Union Label & Accessories Ltd.

Union Label & Accessories Ltd– Site Layout Plan

Observations

Rafter of grid 13

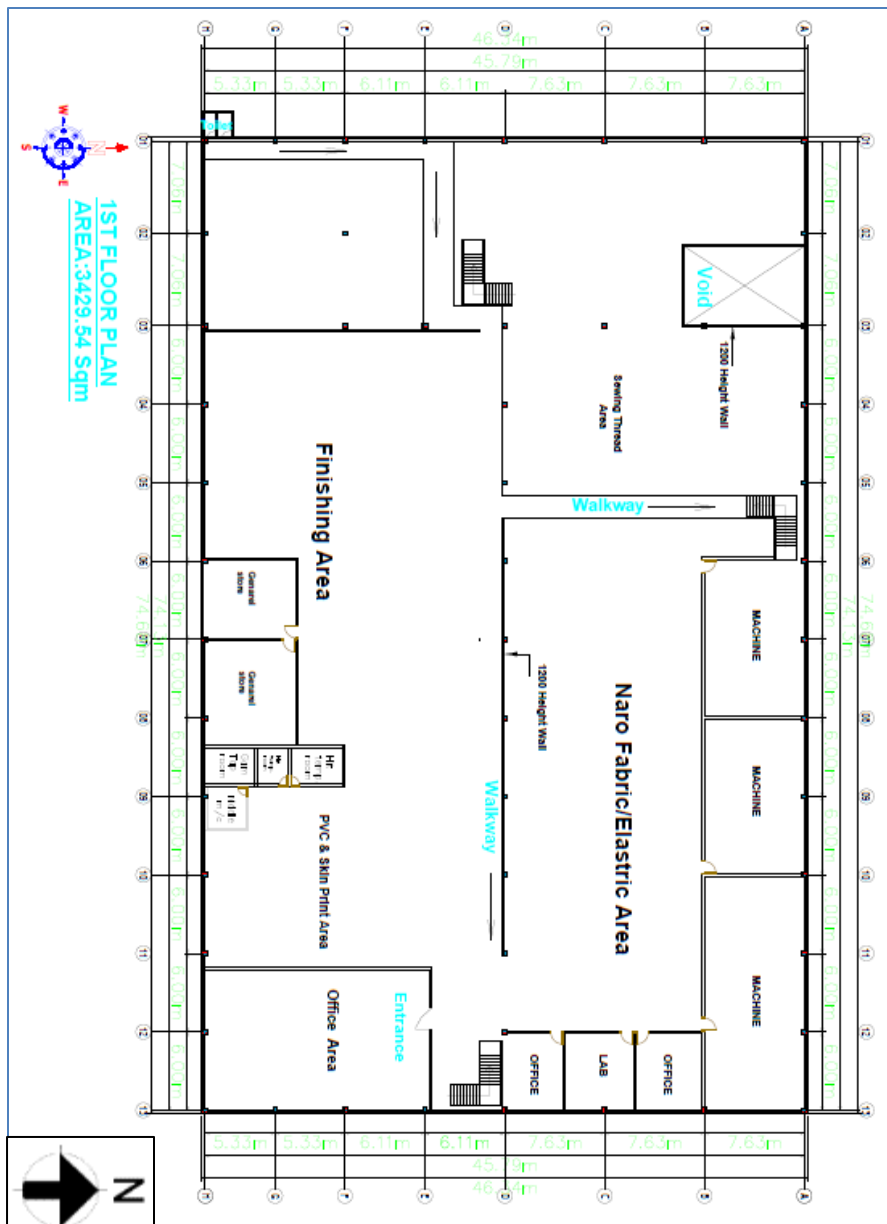
As per the recommendation of prepared EA the factory carried out the retrofitting work except the grid 11, 12 and 13. Additional flanges were not fully added to the rafter of grid 11, 12 and 13.

Prepared EA required to revise as per updated drawings and submit along with retrofitting drawings to RSC. Remedial works must be carried after getting acceptance of EA from RSC.

Vibration observed at the first floor

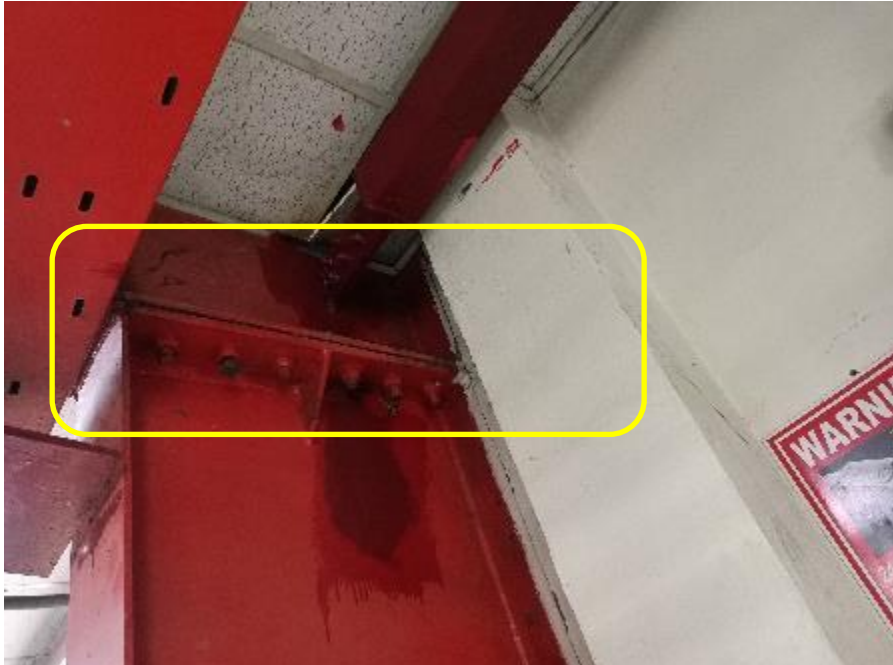
During inspection, significant vibration was observed at the first floor of the Main Shed due to the spinning machine's operation. Building engineer is required to measure the vibration and to investigate whether the vibration is impacting the structure or not and to take proper measure accordingly.

Gap observed in connections

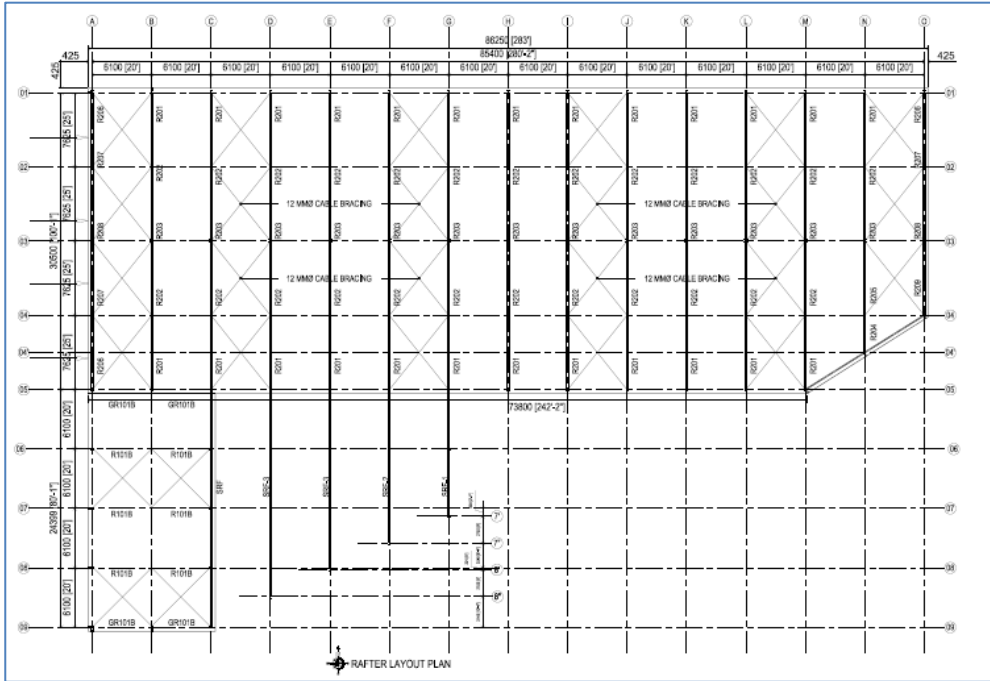
Significant gaps were observed in Rafter-column joint at several locations. Also, loose cable bracings were found. Building engineer is required to carry out suitable remedial works for the gap and tighten the loose bracing where necessary.

Rafter without flange bracing

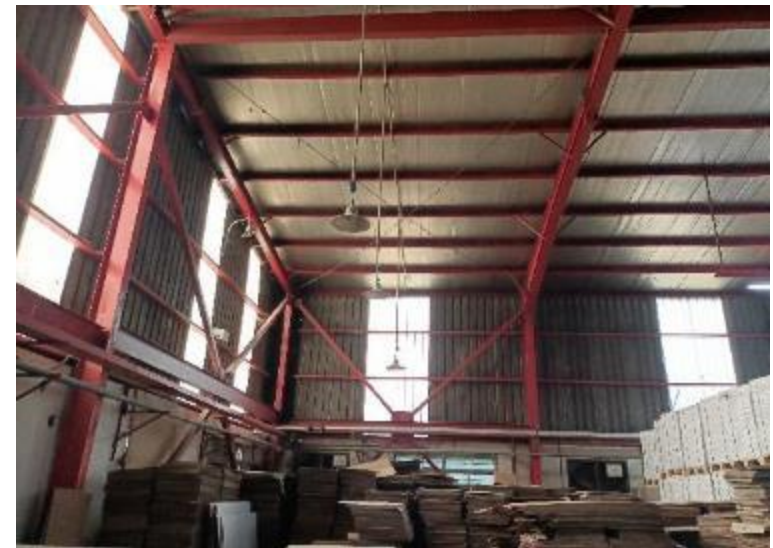
Sectional details of Grid D, E, F & G and corbel beam details were found missing in the provided as-built drawings. On the other hand, bracing layout were not matched with the as-built condition. The building engineer is required to update the drawings providing the details of all structural member.

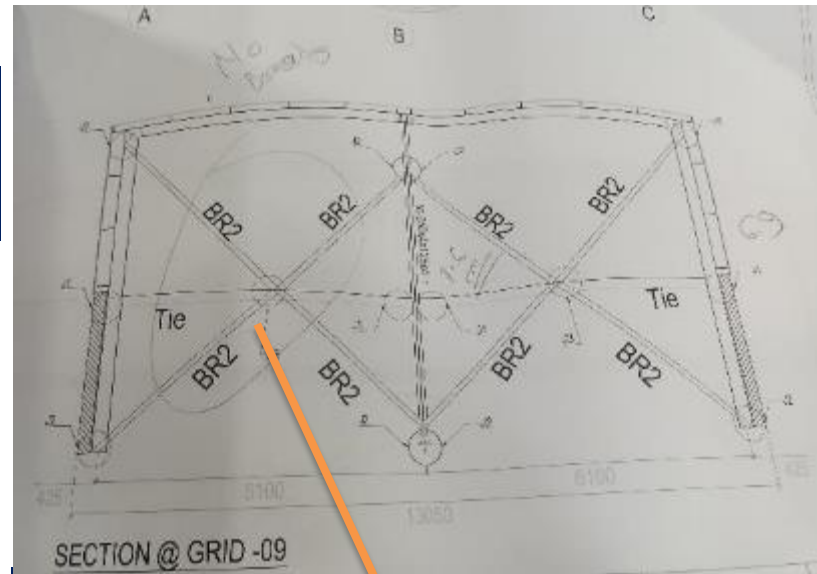
Vertical bracings were found missing at southside of the shed. On the other hand, compression strut were not observed at south part of the shed.

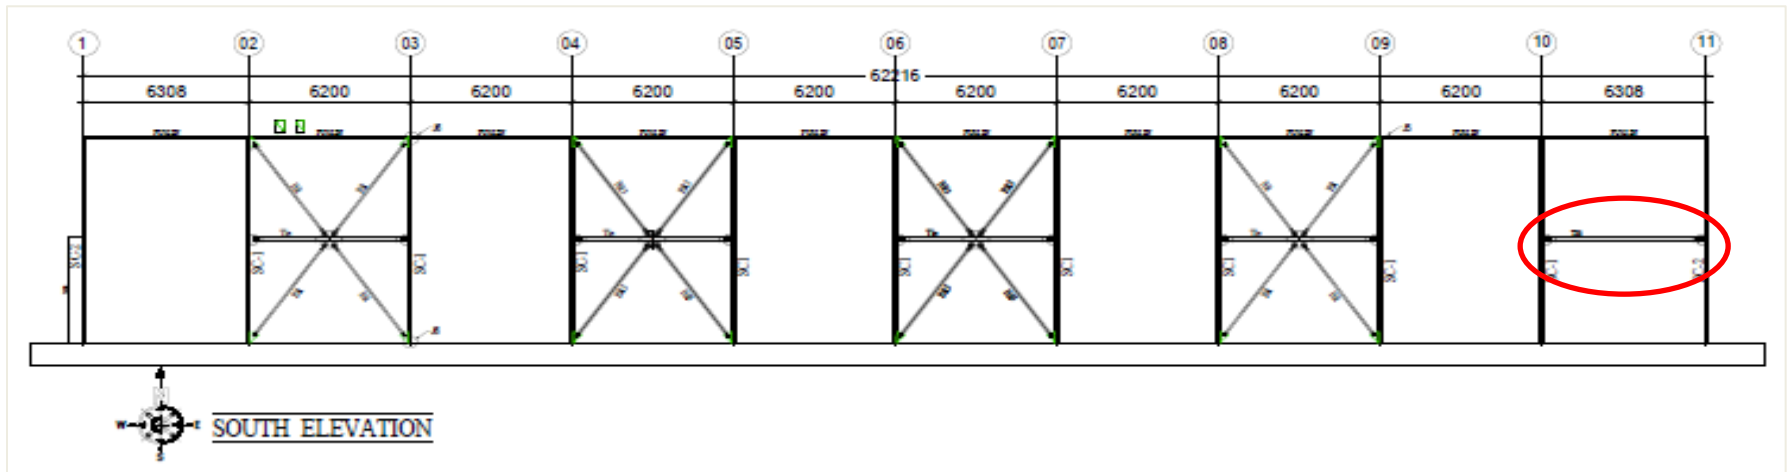
Moreover, in the provided design report material specification (no test report steel plate), details calculation of wind and other input values are not mentioned. Before submitting the EA, the factory is required to incorporate the all the issues in revised EA.

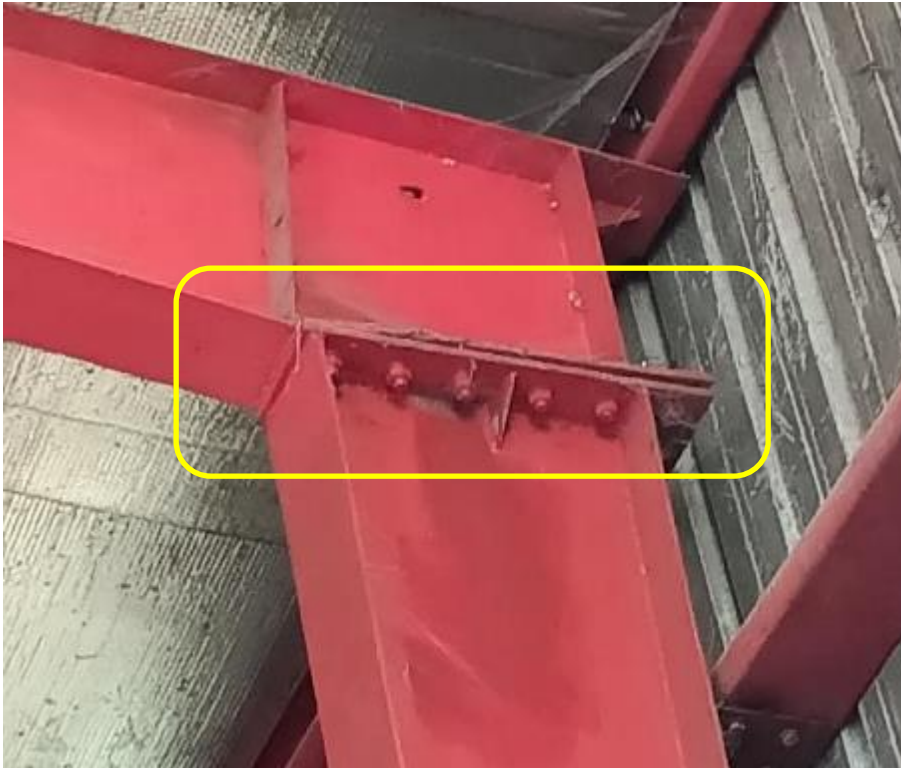
Significant gaps observed in Rafter-column joint at several locations. Building engineer is required to carry out suitable remedial works.

Apparently inadequate connection

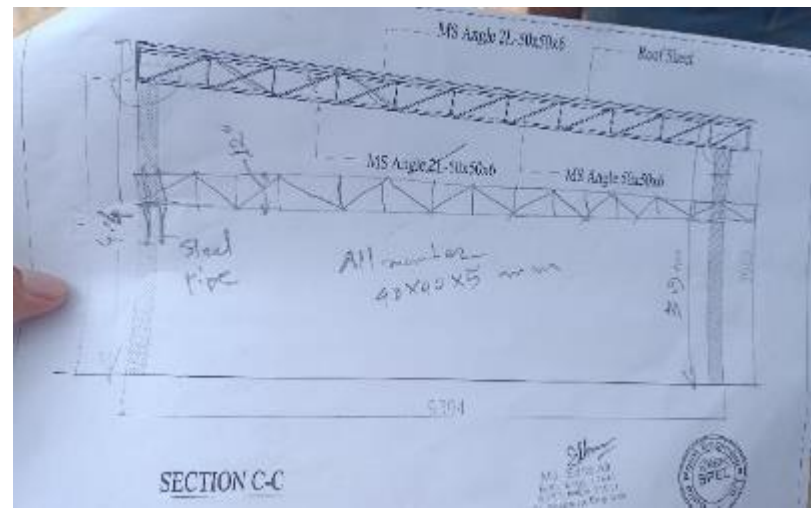
Apparently Inadequate structural member, poor connection details were found. Building engineer is required to check the adequacy of the steel members & connection for uplift and lateral forces otherwise replace with engineered structure.

Truss connection with steel column

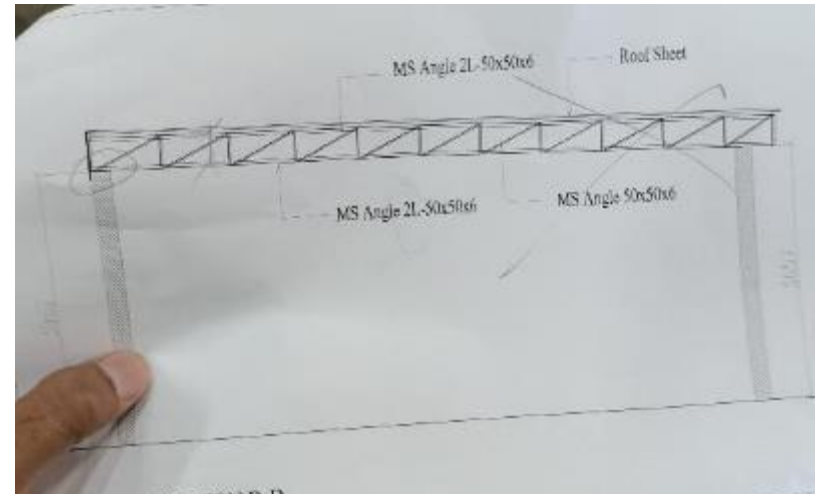
Apparently inadequate connection between truss and Steel pipe column was observed. On other hand connection details or proper drawings were not found on site. The building engineer is required to check the connection adequacy of the truss against uplift force of wind.
